Test Bench Analysis
Zong International Ads1258Accumulator

Rev -, Jan 19, 2011

4.0 TEST BENCH SCREEN SHOTS

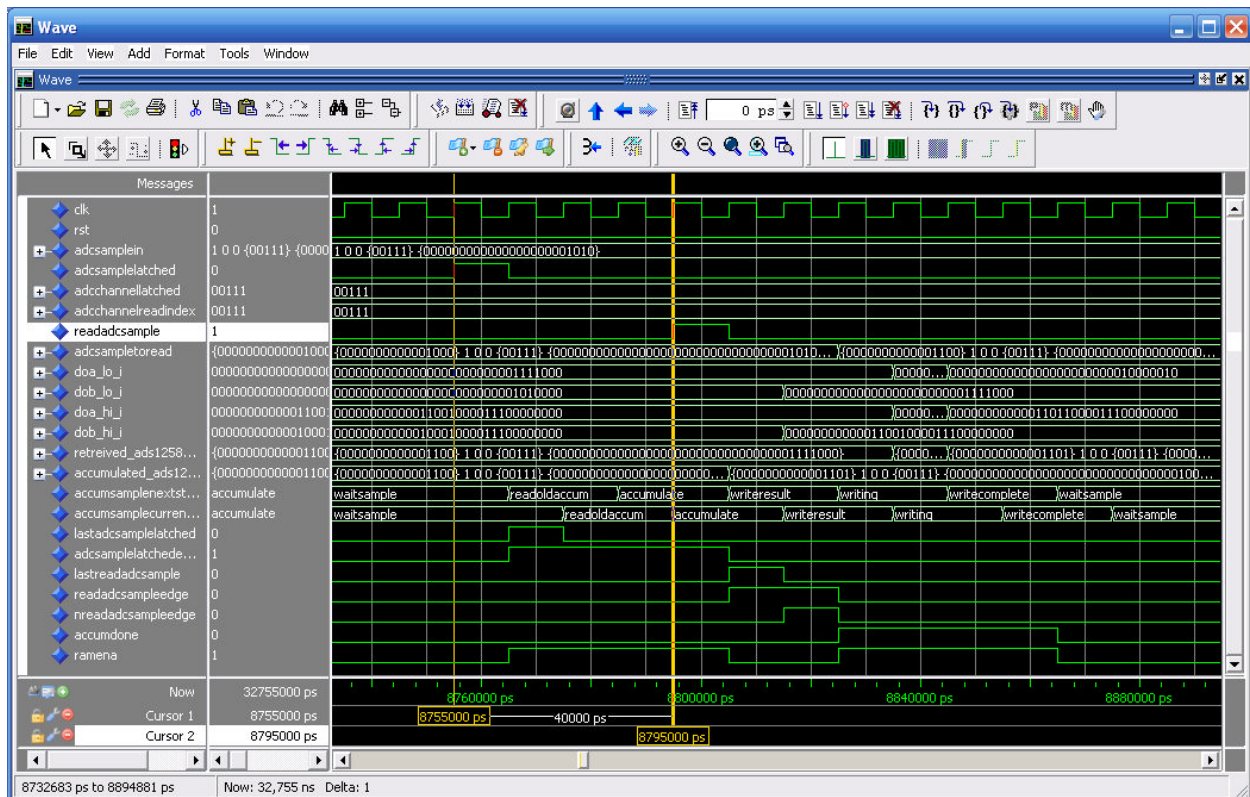
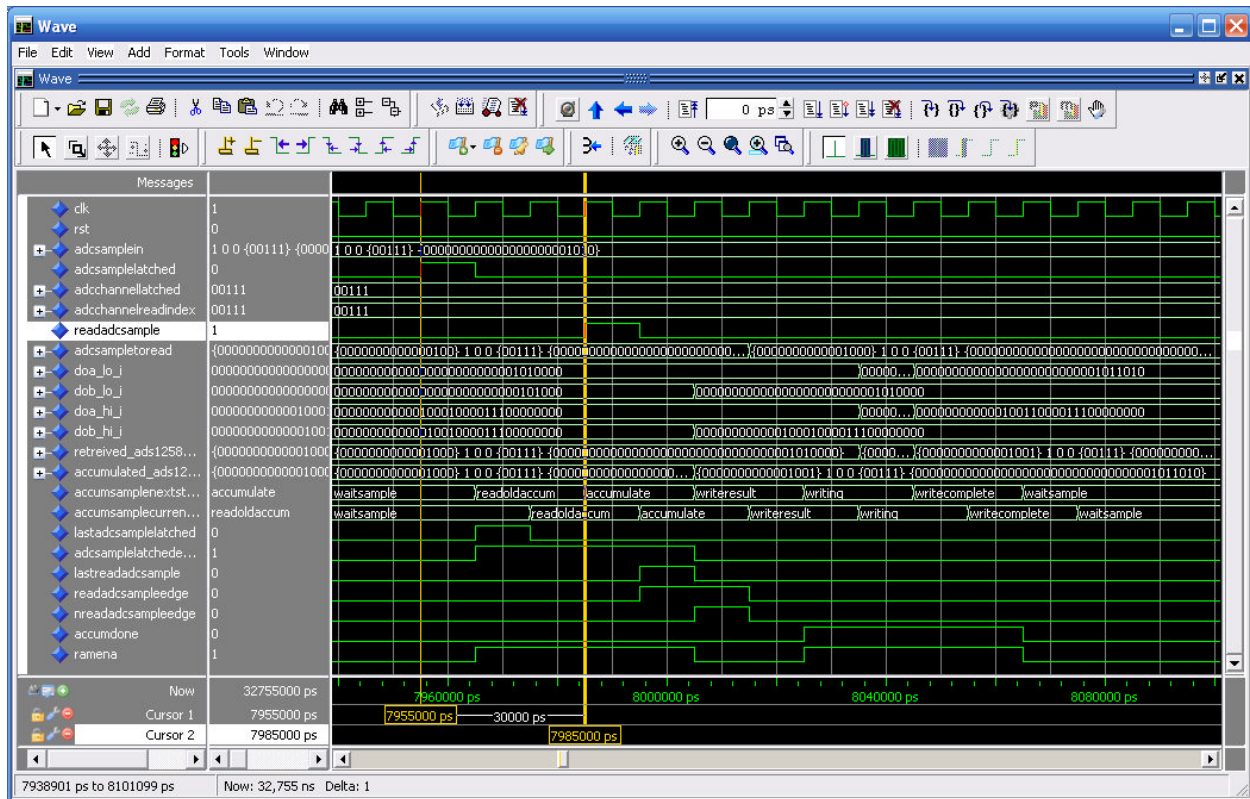
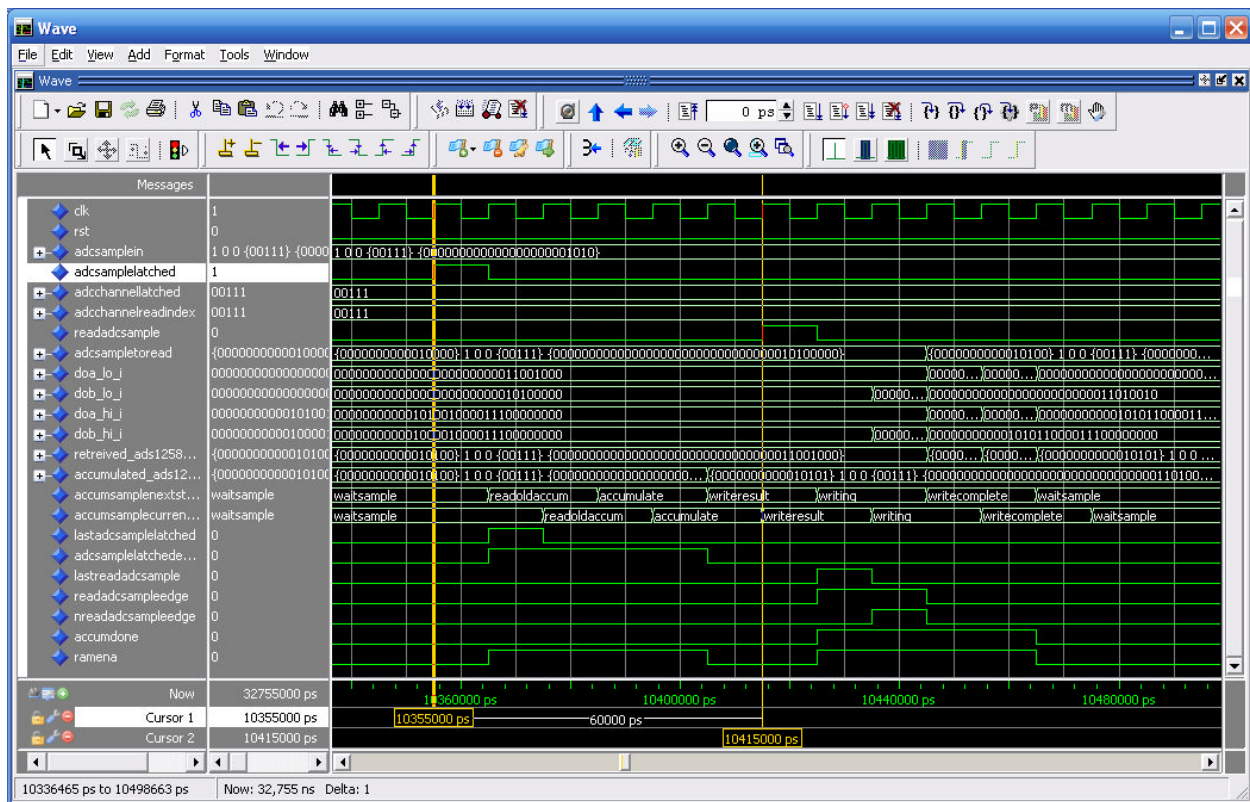
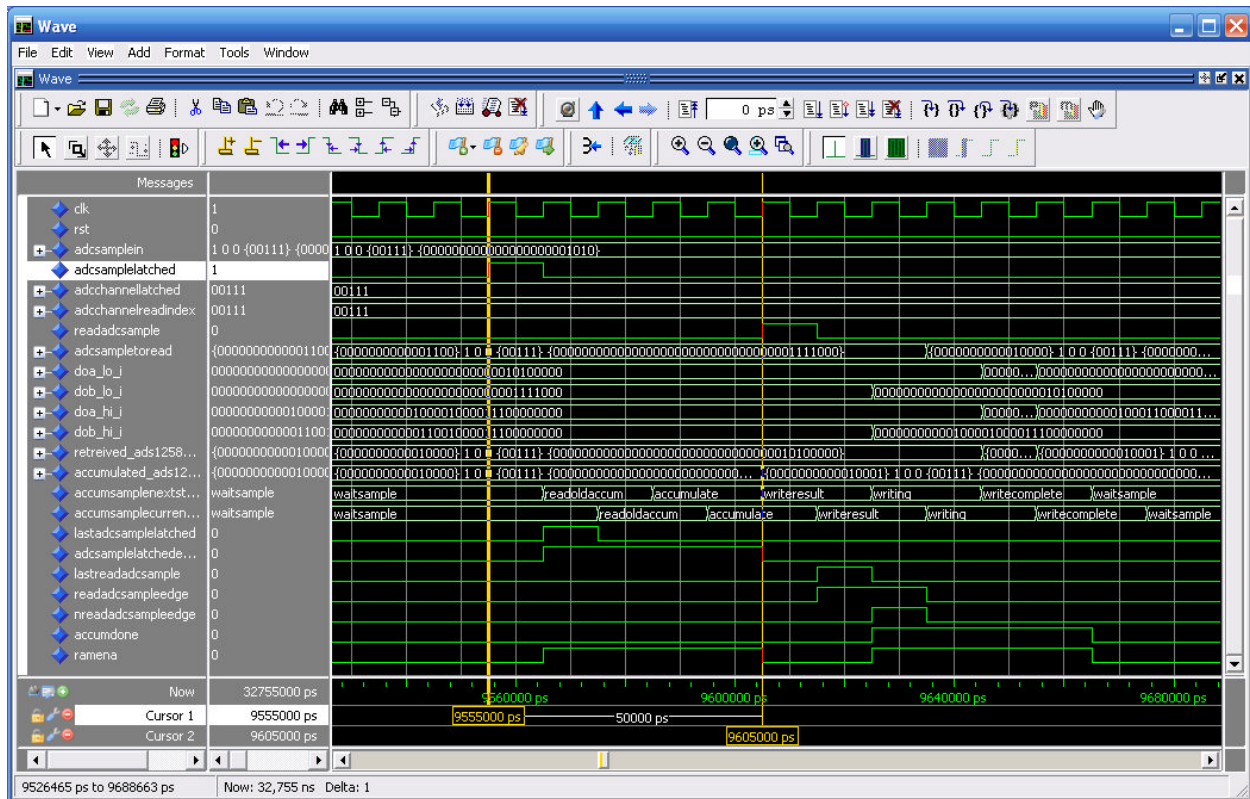
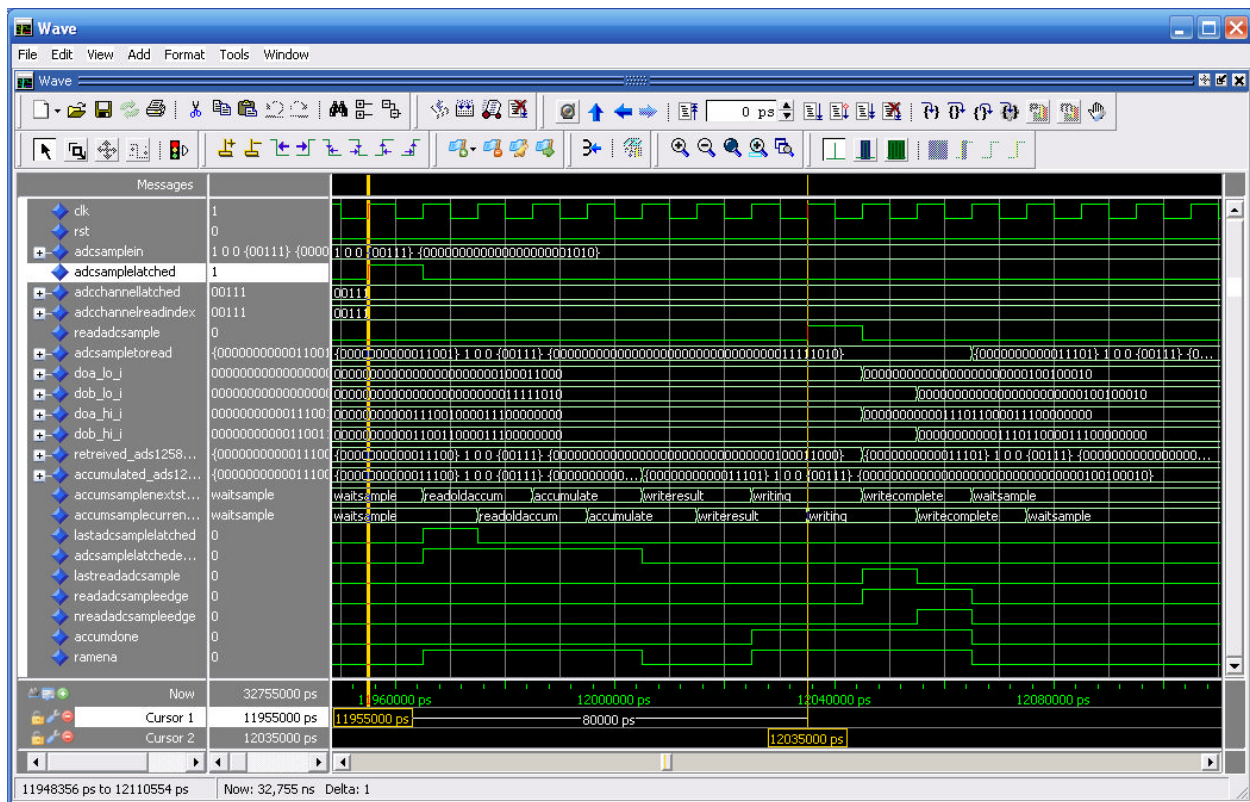
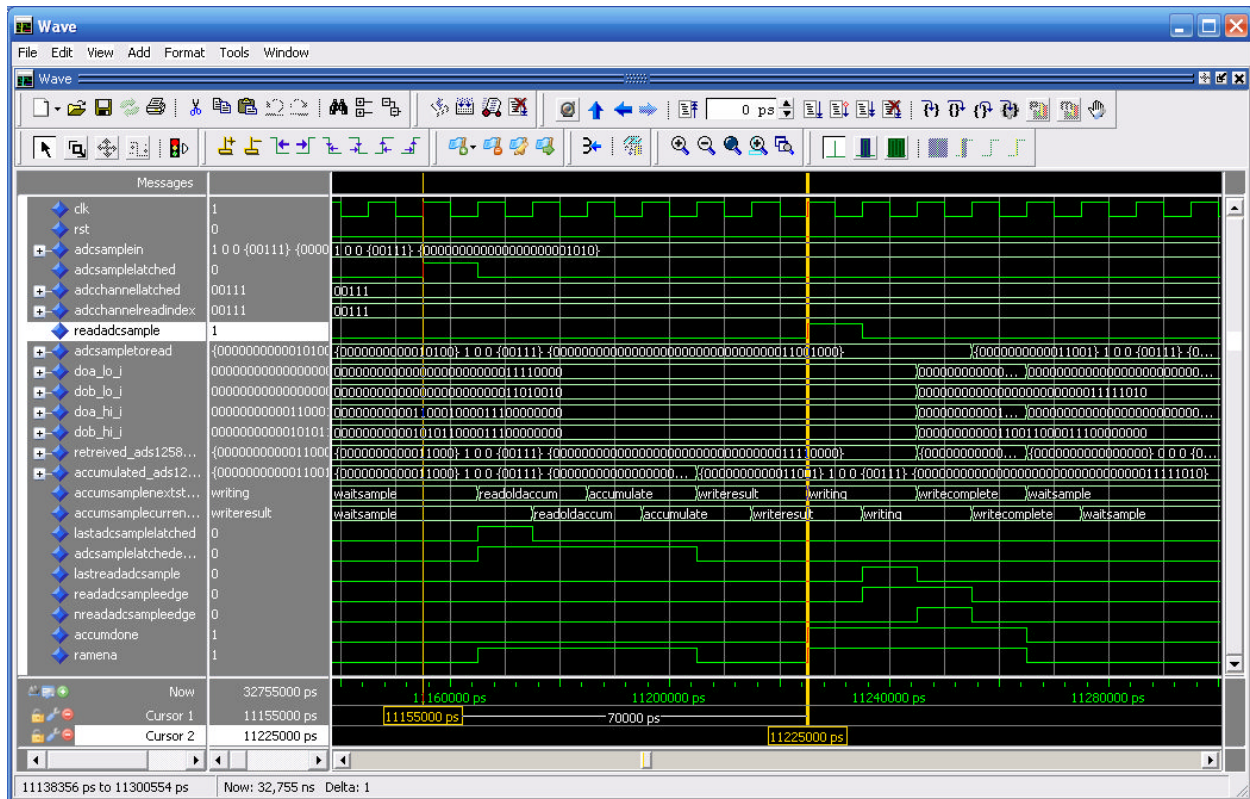
- During the course of simulation there were six cases where the relative timing of the microcontroller read in relation to the ADC update resulted in an erroneous value being loaded into the accumulator. Screen shots of these error scenarios are included later in this document. While there are subtle differences in the internal signal timing for each of these error conditions the root condition of the failure is the same. The errors seem to result from the microcontroller attempting to reset the contents of the accumulator after the state machine that is capturing the ADC samples has read the current value out of the accumulator and is then going to subsequently add the new sample to this value and then write the updated accumulated value back into memory. When this updated value is written back after an accumulator reset has been performed it essentially has the effect of making it as if the accumulator reset never happened. While this, in and of itself, does not account for the “missing” captured samples that have been observed it is still probably not the desired mode of operation.

- What I think may be even more problematic is what happens in the situation captured in the final error waveform where the final write cycle of the update to Port A overlaps with the clearing cycle of the write occurring on Port B. While it is a dual port RAM, it is my understanding that concurrent writes to the same address on the separate ports results in undefined behavior. While not reflected very well in this functional simulation which features a direct instantiation of the memory primitive I believe that higher level behavior models typically default to generate warnings for “memory collisions”. I believe the only way to avoid this potential corruption is to architect the module in such a way that ensures that concurrent writes to the same address never happen. This is obviously complicated by the fact that the interfaces on both sides of the accumulator are essentially operating asynchronously. I believe the only options for avoid this is to closely control the timing to both sides

The primary difference between each of the subsequent screenshots (SECTION 4) is the delay between the arrival of these two pulses. The delay ranges from 30-80ns (with each 10ns delay representing one clock cycle) and is shown in each screen capture by the delta value between the two cursors which are placed at the rising edge of the aforementioned signals.

As the delta between the first two signals (`adcsamplelatched` and `readadcsample`) increases by one clock cycle in each screenshot, the relative timing of the last two signals (`readadcsampleedge` and `nreadadcsampleedge`) shift to the right by the same amount. In all cases though the position of this read and subsequent write to Port B occurs after the accumulated value has been already been read out of Port A which will subsequently be added to the current sample and stored back in the accumulator RAM. In the last four screenshots the write to Port B overlaps with the write to Port A. Of those four, in all but the last screen shot since the update to Port A actually spans four clock cycles and continues to be applied to the BlockRAM even after the clearing write to Port B the end value stored at that particular location in memory is its old value added to the current sample from the ADC. In the last screenshot I believe the actual contents of the RAM are unknown because a write is being attempted and concluded on Port A and Port B at the same time.

of the interface, or restructure the logic such that writes are only performed on one of the two memory ports.
